# Public Proposals Report

# 2020 Square Footage: Method for Calculating ANSI Z765

February 7, 2020

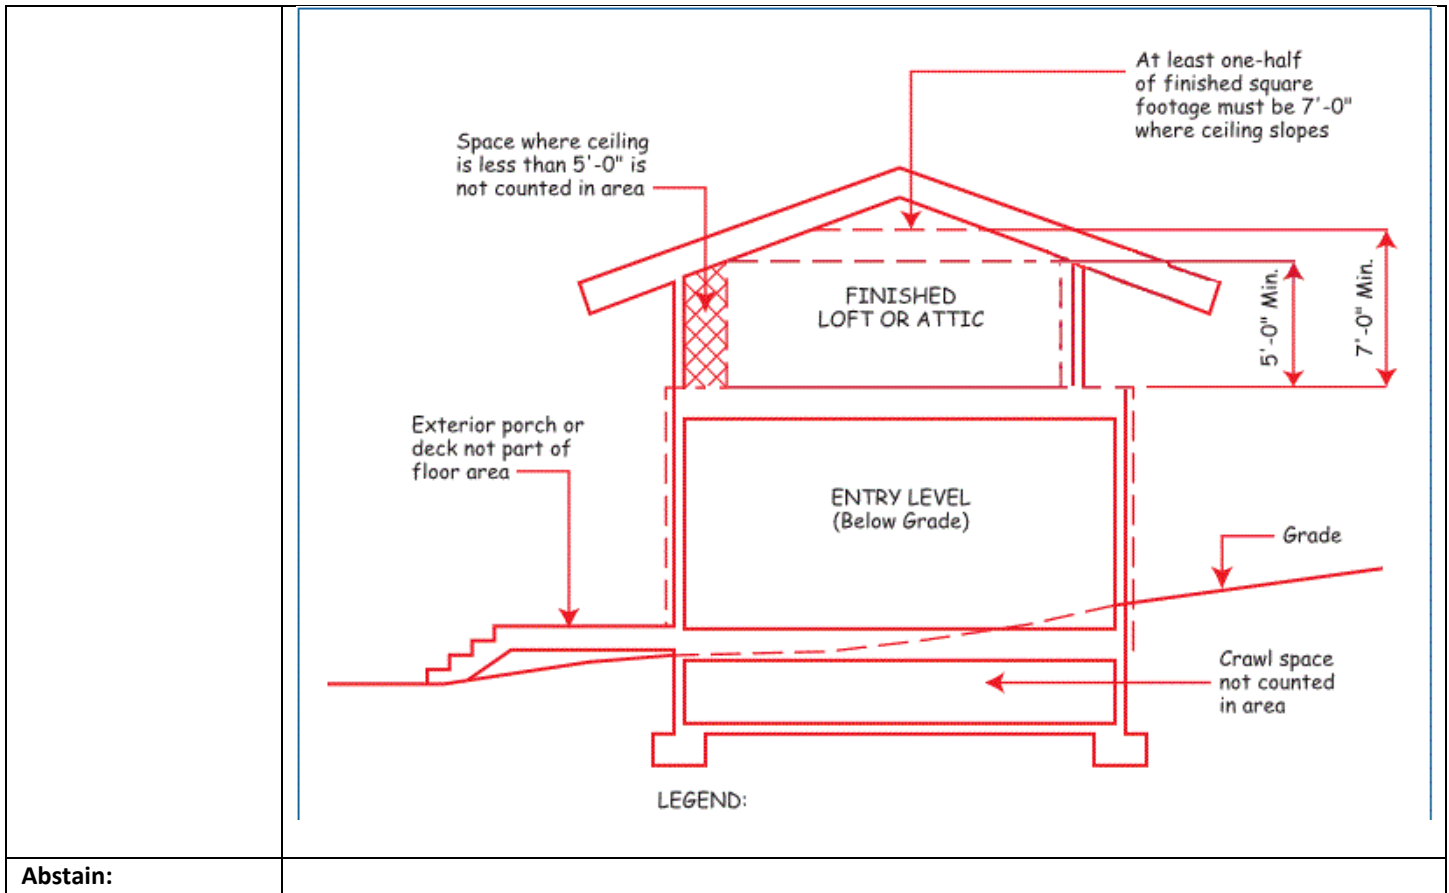
<b>Log 11 - Section 3. Calculation of Square Footage – Ceiling Height</b>		<b>Final Formal Action: Approve as Modified</b>
<b>Submitter:</b>	Jean M. McCarty	
<b>Requested Action:</b>	Request for Clarification/Modification	
<b>Proposed Change:</b>	5' walls on sloping ceilings	
<b>Reason:</b>	<p>95% of appraisers measure to 5' mark and then add for the studs. ANSI does not specifically address adding for the studs and this needs clarifying. The American Measurement Standard specifically says you do not add for the studs. Following ANSI principles minutely says they should not add for the studs but it is not specifically stated. The illustrations indicate stopping at the 5' mark and not allowing for the studs. The problem with applying ANSI as a valuation tool or even a construction tool is that it penalizes the house when stopping at the 5' level on the ceiling. It penalizes the house on the Cost approach because the cost of construction is still there and on the sales approach because use of space under a 5' wall is still functional. Consumers do not view the space with a ceiling height of less than 5' so dysfunctional as not to add to value. Our problem of creating a line item separate on the sales grid to account for heated/cooled space in this circumstance is more confusing to the consumers and users of appraisals.</p>

<b>CC Reason:</b>	Implementation of the comment.
<b>Ballot II Results on Committee Action:</b>	Eligible to vote: 13 Agree with committee action: 7 Disagree with committee action: 2 Abstain: 1 Non-voting: 3
<b>Ballot Comments</b>	
<b>Agree with committee action:</b>	
<b>Disagree with committee action:</b>	<p><b>Bryan Reynolds:</b> Section 3. Ceiling Height - This proposed change will create more confusion than clarity in the valuation profession and for other users. As a national instructor, I witness many students are already confused with this section and this attempt for clarity will fail. I strongly recommend this change not be made to this section.</p> <p><b>Darwin Ernst:</b></p>  <p>The drawing I provided in my ballot response is more clear than the one that was provided in the ballot, but I would offer an updated version of this edited figure/image (see attached) to members based on my opinion that the upper floor measurement of all sloped ceiling heights should be restricted to the point of the sloped ceiling at the 5' mark above the floor, regardless of whether there is an exterior wall, pony wall, or any other type of wall beyond the point where the upper floor's ceiling height is 5' above the floor, so there is consistency in the upper floor measurement by all users of the standards. The proposed modification (see below) in item 11 to include the width of an exterior wall on upper floors beyond where the ceiling height reaches a point on the slope of an upper floor ceiling at a point 5' above the floor will be confusing to many potential users, so I am hopeful that we can discuss this motion further.</p>

<b>Agree with committee action:</b>	<p><b>Darwin Ernst:</b></p> <p><b>Ballot Item No. &amp; Log No.</b></p> <table border="1"> <tr> <td style="text-align: center;">11820</td> <td> </td> </tr> </table> <p>I believe this image is ambiguous to users... I also believe the current majority of the committee members disagree with me and think it will be appropriate for users to include the width of an exterior wall when measuring an upper floor area; however, the current image is still ambiguous in my opinion. As shown in the close-up image included below, the current revised version of Figure 5 is open to interpretation...</p> <p>If the committee decides to include the dimensions of an exterior wall in the determination of upper floor square footage, instead of consistently applying the standard of measuring all such areas based on the interior ceiling height of 5' from the floor, whether there is an exterior wall or not, we need to make sure the drawing identifies the exact spot where the ceiling height is 5' on the interior and where the exterior wall height is less than the 5' interior ceiling height.</p> <p>I would argue that for consistency in measuring this upper floor area, we should place the dotted red line on the right side of the wall and measure to the interior ceiling height of 5' no matter whether it is adjacent to an exterior wall or not, which is also in-line with the definition below.</p> <p><b>Ceiling Height Requirements</b></p> <p>To be included in finished square footage calculations, finished areas must have a ceiling height of at least 7 feet (2.13 meters) except under beams, ducts, and other obstructions where the height may be 6 feet 4 inches (1.93 meters); under stairs where there is no specified height requirement; or where the ceiling is sloped. If a room's ceiling is sloped, at least one-half of the finished square footage in that room must have a vertical ceiling height of at least 7 feet (2.13 meters); no portion of the finished area that has a height of less than 5 feet (1.52 meters) may be included in finished square footage.</p> <p>Figure 4 also has to be revised, as we previously discussed to match whatever measurement is deemed appropriate.</p>	11820	
11820

<b>CC Action:</b>	Approve as Modified
<b>Modification of Comment:</b>	<p>Replace Figure 5 with the following figure provided by Jeremy Wright.</p> <p><i>Staff Note: See <a href="#">Appendix A</a> for an additional copy of the submitted figure.</i></p>
